RE: Submission of 2019 Geotechnical Inspection Report No. 2 (September 2019)

2019 Geotechnical Inspection Report No. 2

Annual Geotechnical Inspections – 2019 Report 2. Mary River Iron Mine – Nunavut

Figure 26: Water treatment pond adjacent to the waste rock dump and MS-08 (ice and snow covered).

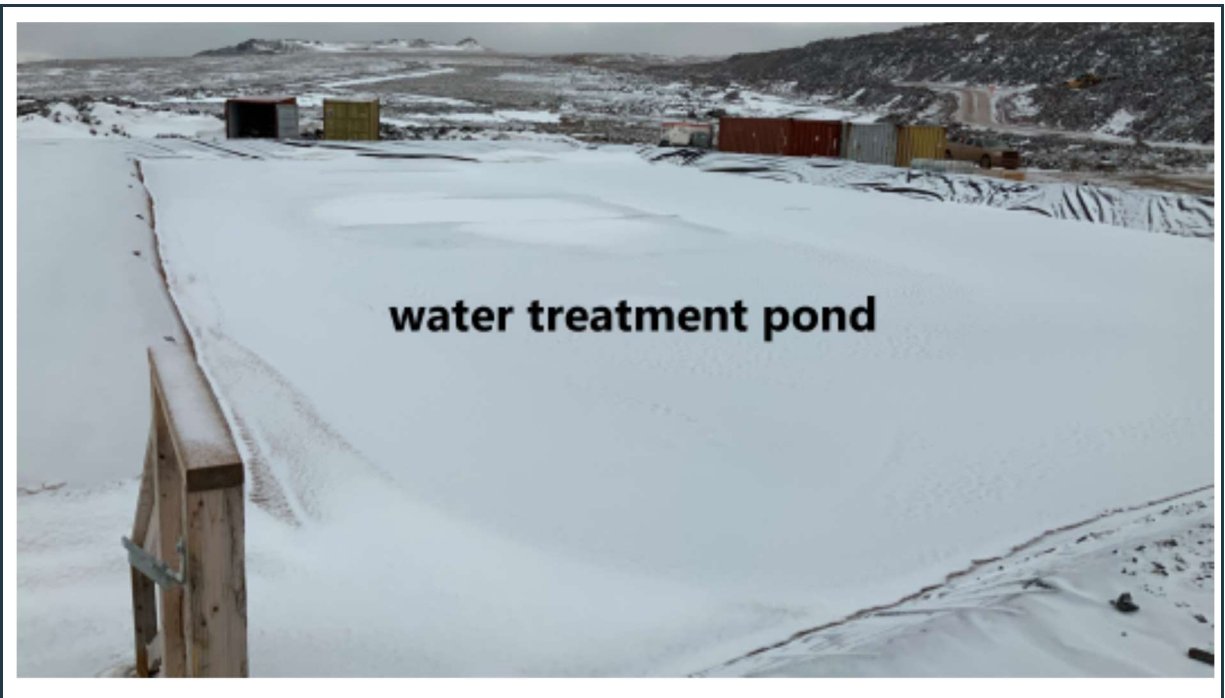
Water from the pond is pumped to the nearby designated facility for treatment. There is a lined treatment area located immediately next to the treatment plant with stable perimeter berms. Water treatment issues in relation to this area have not been reported and the entire facility appears to be fully functional. At the time of the inspection, the water in the pond was covered with ice and snow, as shown in Figure 26.

Figure 43: Perimeter berm at the HWB-4 cell, with exposed geotextile and liner.

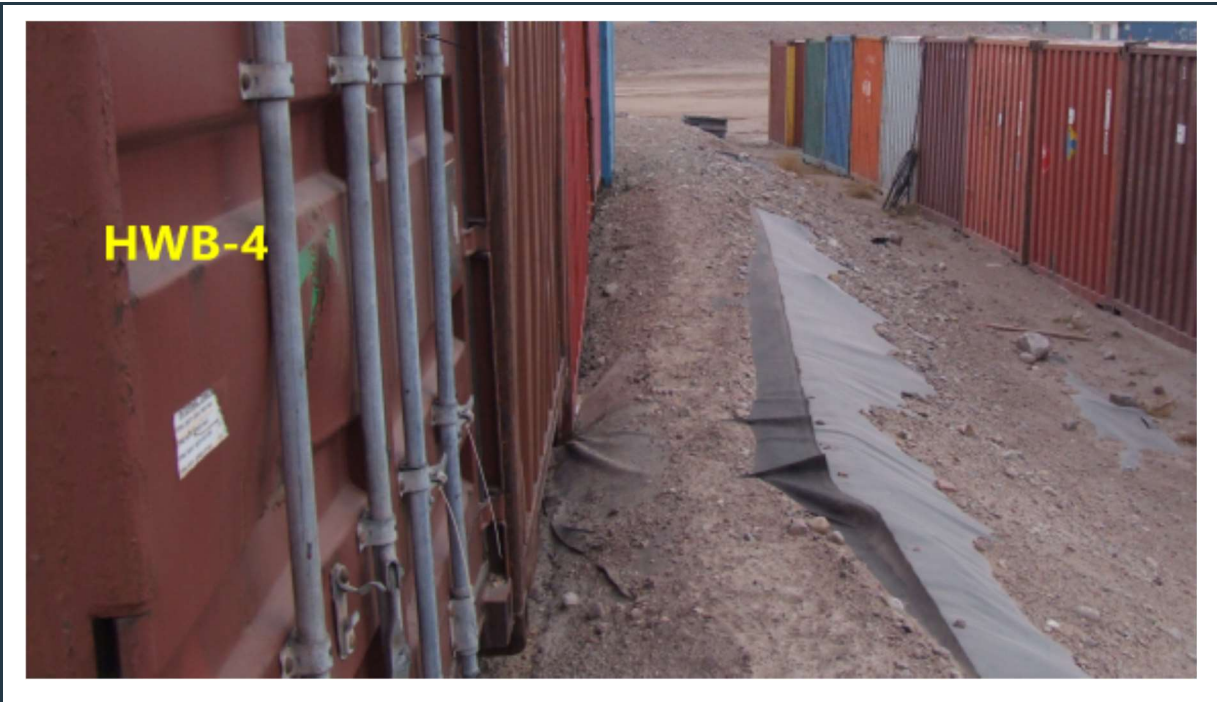
The liners within the ponds are intact; however, they are exposed at a few locations on the crest and downstream slopes of the berms as previously identified during the first 2019 inspection.

The HWB-3 and HWB-4 cells are located immediately next to each other (twin-cells) and contain shipping containers only, as shown in Figures 42 to 44. The berms appear to be in good condition with no visible signs of slope instability (e.g., movements or settlement). The liner was found to be exposed at a few locations on the crest and downstream slopes of the berms, as shown in Figures 43 and 44. It is recommended that all exposed liner areas be regraded and covered with a protective layer of granular fill (clean sand and gravel), to ensure proper liner performance in the long run.

Baffinland Action: Re-grade and cover areas where liner is exposed with a protective layer of granular fill (clean sand and gravel) prior to July 2020.

Figure 48: Stable berm at the MP-04 landfarm, with exposed liner on the downstream slope.

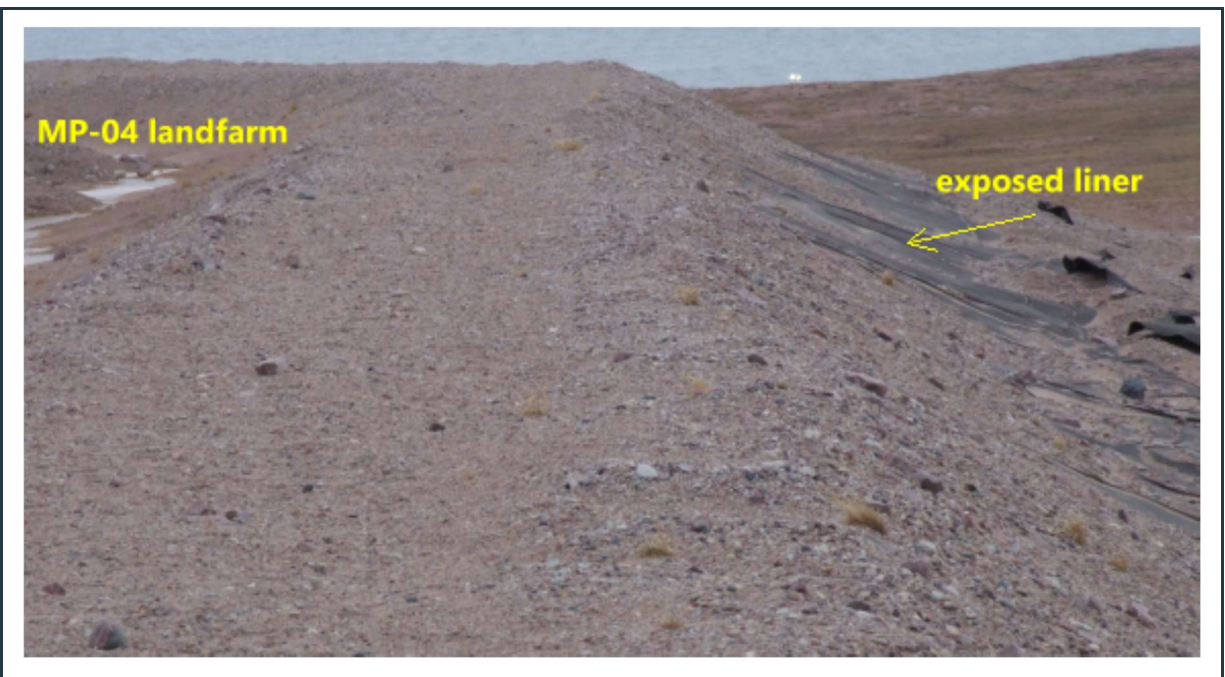
Exposed liner was visible on the downstream slope of sections of the MP-04 berm, particularly along the north berm, as previously noted during the first 2019 inspection.

The MP-04 and MP-04A cells are located south of the port complex at higher elevation, adjacent to the rock quarry. MP-04 is a large landfarm cell that predominantly stores contaminated soils, as shown in Figure 47. The berm structure around the cell did not exhibit any signs of instability or evidence of seepage. However, the liner was found to be exposed (e.g. lacking protection of soil cover) on the downstream slope sections of the berm. This was particularly prominent along the north berm. It is recommended that the respective exposed liner areas (see Figure 48) be provided with protective gravel layer (e.g. wind uplift prevention).

Baffinland Action: Regrade and cover areas where liner is exposed with a protective granular fill (clean sand and gravel) prior to July 2020.

Figure 59: Water seepage through and beneath the road embankment near the tote road culverts.

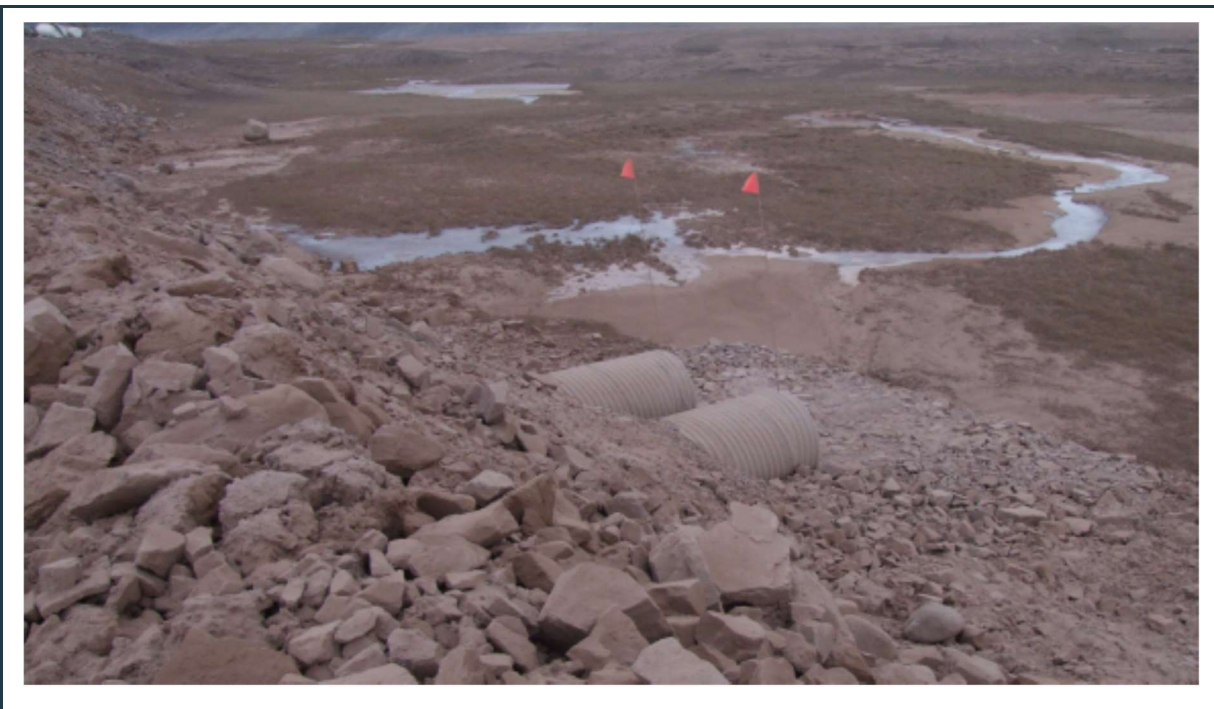
The flow of water may soften the original native subgrade beneath the road embankment and eventually could create some instability of the embankment.

Surface water from higher elevation around the rock quarry is collected in drainage ditches and conveyed down the slope through corrugated galvanized steel culverts, installed under the quarry road and then under the Tote Road. The water in the ditches is then conveyed to small natural ponds, located along the west side of the Tote Road, as shown in Figure 59. As reported earlier, the fill in the area (road embankment and slope cover) comprises crushed rock fill, and therefore a portion of the surface water have the tendency to bypass the two culverts beneath the Tote Road embankment (through-flow) and finds its way to the nearby ponds (see Figure 59) in open, shallow channels. The flow of such water may

soften the original native subgrade beneath the road embankment and potentially destabilize the road embankment. As recommended in the August 31, 2019 inspection report, and to increase the stability of the Tote Road's embankment in the affected areas, construction of a rock fill toe berm is recommended along the affected sections (approximately 50 m south and north from the twin culverts, shown in Figure 59) of the Tote Road.

Baffinland Action: Regrade the upstream area leading to the culverts by placing additional rock fill along the affected sections (toe-berm reinforcement for increased embankment stability) prior to spring freshet 2020.
